PREDETERMINATION SETTLEMENT AGREEMENT

CP# 10-18-72688
HUD# 07-19-0518-8

Complainant specifically alleged at 2301 Ingersoll Avenue, Soll Apartments (“Soll”), three features in the common areas and two features within two third-floor units appeared inaccessible to a person utilizing a wheelchair for mobility – (1) the width of the car-accessible parking space was measured at 95”, which is less than the 96” minimum width required; (2) the width of the van-accessible parking space was measured at 96” and the width of the adjoining access aisle was measured at 60 ½”, which is less than the 96”-minimum required for access aisles when van-accessible parking space is less than 132” wide; (3) the heights of the midlines of the keyholes at the top four rows of the mail compartments at the wall-mounted mailbox station were measured at 66” (top row), 62 ½” (second to top row), 59” (third to top row), and at 55 ½” (fourth to top row) – all of which are higher than the 54”-maximum allowed for a parallel approach by persons using a wheelchair; (4) the heights of the interior thresholds at the sliding glass doorways in Units 329 and 333 was estimated to be 1 7/8”, which exceeds the ¼”-maximum al

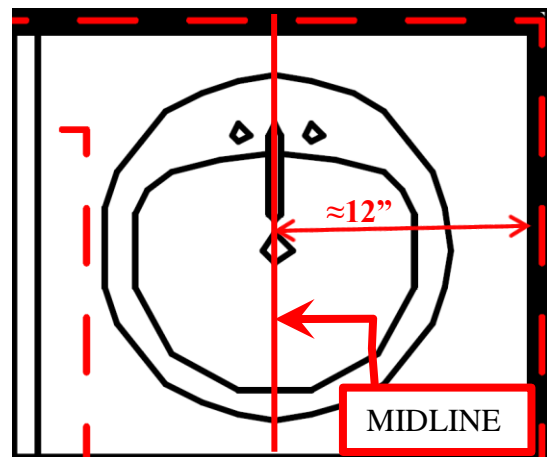
3) Based on the requirements from the Guidelines and ANSI 1986, a 30” by 48” clear floor space size centered on the bathroom sink is required, which means the midline of the sink must not be any closer than 15 inches to an adjacent wall when the sink has sufficient space underneath for knee clearance. ICRC investigators verified there is sufficient knee clearance under the sink in the women’s bathroom adjacent to the fitness center, and that all the surfaces under the sink are finished. The midline of this bathroom sink was measured to be 14 ³/₈” away from the nearest obstruction, which is the wall to the right of the sink.⁶

The plans submitted by Respondents include a scaled drawing of the women’s bathroom adjacent to the fitness center, which shows that the midline of the sink was designed to be approximately 12” away from the wall to the right of the sink. This dimension is portrayed in the captioned diagram below:

As designed and built, the sink in the women’s bathroom adjacent to fitness center is too close to the wall, rendering this common-use bathroom unusable by persons using wheelchairs.

- 1) Respondents will move the countertop of the sink in the women’s bathroom located near the fitness center to increase the distance from the midline of the sink to the wall to no less than 15”.

- 1) ICRC concurs with Respondents’ proposal to move the countertop to increase the distance from the midline of the sink to the wall – in the women’s bathroom adjacent to the fitness center – to no less than 15”. ICRC will require that this retrofit be completed within 90 days from the date of the Closing Letter from ICRC.
- 2) ICRC concurs with Respondents’ proposal to install accessible transition bevels with 1:2 slopes at the doorways to the balcony in units that have thresholds exceeding the ¼”-maximum height. ICRC will require that this retrofit be completed within 90 days from the date of the Closing Letter from ICRC or sooner if requested by a tenant because of a disability.
- 3) ICRC concurs with Respondents’ proposal to (i) move the countertop in the Master Bathroom of Unit 133 to increase the distance from the midline of the sink to the wall to no less than 24”; and (ii)

(b) Respondents agree they will reinstall the countertop of the sink in the women’s bathroom adjacent to the fitness center further away from the wall, such that the midline of the sink will be no less than 15” from the nearest obstruction, as required in the Manual and 2010 ADAAG, for sinks with sufficient knee and toe clearance to allow for a forward approach by persons using a wheelchair.

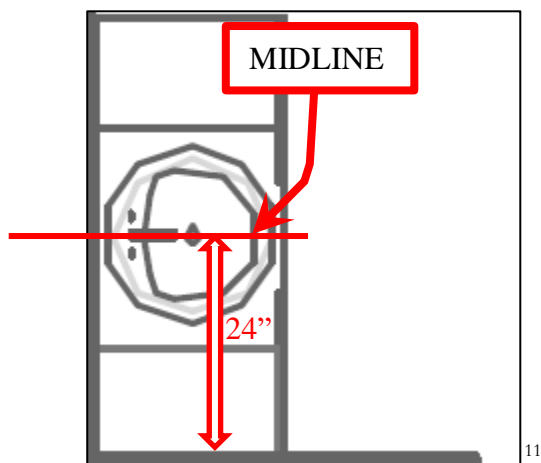
4) The thresholds at the sliding glass doorways of all inspected units lacked 1:2 beveling. The interior threshold heights above the interior finished floor at the sliding glass doorways were measured by ICRC Investigators at 5/16” in Unit 333, 9/16” in Unit 133 and 454, and 17/32” in Unit 329, which exceeds the 1/4-inch maximum allowed for thresholds without beveling.⁸ No specific instructions or diagrams for the installation of the sliding glass doorways were found in the construction plans. These thresholds are too high, rendering the doorways unusable by persons using wheelchairs.

The heights of the interior thresholds reported by Respondents, and cited on pages 3 and 4 of the current agreement, are not consistent with the height measurements taken by ICRC Investigators. ICRC Investigators utilized a digital level which was placed on top of the highest portion of the threshold to ensure the accuracy of the measurement made from the top of the threshold to the interior finished floor level – consistent with the manner that the height measurement is portrayed in the diagram above obtained from the Manual.⁹

- 2) Respondents will install accessible transition bevels with 1:2 slopes at the doorways to the balcony in units that have thresholds exceeding the ¼”-maximum height.

(b) Respondents agree to install an accessible transition bevel with a 1:2 slope in Units 133, 329, 333, and 454 at the interior side of the threshold in the doorway to the balcony, as required by the Manual to be compliant with the 3/4"-maximum height allowed at the beveled interior thresholds of secondary sliding-glass doorways.

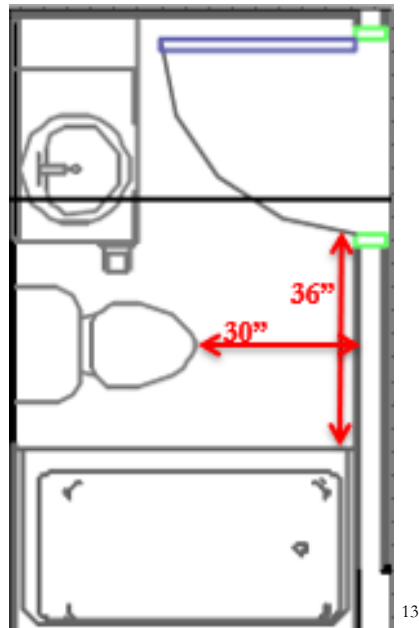
5) In Unit 133, the midline of the sink in the Master Bathroom was measured to be 23 ³/₈" from the adjoining wall, which is less than the 24"-minimum requirement if the base cabinets are not removable.¹⁰ The base cabinets in this bathroom appeared not to be removable to ICRC Investigators because they did not observe the presence of side brackets underneath the sink to support the sink in the event the base cabinets are removed.

The plans submitted by Respondents include a scaled drawing of the Master Bathroom in Unit 133, which shows that the midline of the sink was designed to be approximately 24" away from the wall to the left of the sink. This dimension is portrayed in the captioned diagram below:

If the Master Bathroom would have been built exactly as it was designed, it would have been compliant with the 24"-minimum clearance requirement. However, as built, this bathroom sink is too close to the wall, rendering this bathroom unusable by persons using wheelchairs.

Although this bathroom was designed to be in compliance with the 24"-minimum clearance requirement for bathrooms without removable cabinets, the design did not allow for any of the minor construction tolerances that frequently occur. Not incorporating construction tolerances into the design of the Master Bathroom sink may have contributed to this deficiency.

- 3) Respondents will move the countertop to increase the distance from the midline of the bathroom sink to the wall – in the Master Bathroom of Unit 133 – to no less than 24”. Respondents will measure the distance from the midline of the sink to the adjacent wall in all bathrooms of all similarly designed and built units, and make the same adjustment in units with bathroom-sink midlines that are less than 24” away from the adjacent walls.

(b) Respondents agree they will retrofit the non-complaint bathroom sinks in Unit 133 by replacing the countertop and moving the sink further away from the adjacent wall, such that the midline of the sink will be no less than 24" from the nearest obstruction as required in the Manual, and as shown in the figure below from the Manual:

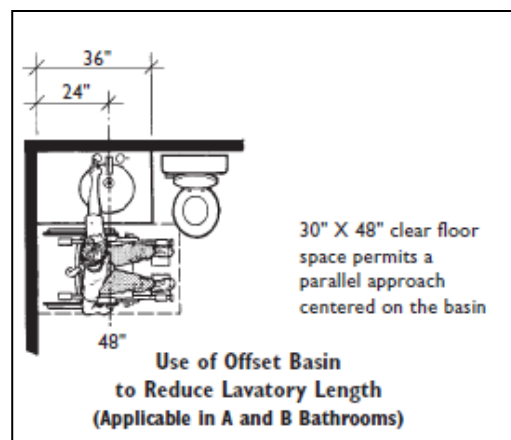
(a) The parties agree the interior threshold height onto the finished floor surface at the unbeveled threshold of the doorway to the balcony in Units 133, 329, 333, and 454 is higher than the ¼-inch

maximum height allowed for thresholds without beveling and less than the 3/4"-maximum allowed with beveling, as required by the Manual.

(c) Respondents agree they will inspect the interior thresholds at the doorway providing access to the balcony of the other units that were not inspected by ICRC Investigators – and are in the same floor-plan groups as Units 133, 329, 333, and 454, as defined in the table on page 3 of the current agreement – to verify compliance with either the 1/4" maximum threshold height if no 1:2 beveling is present or the 3/4"-maximum threshold height if the 1:2 beveling is present. Respondents agree to complete the retrofit required in paragraph (b) above at all units verified to have non-compliant thresholds.
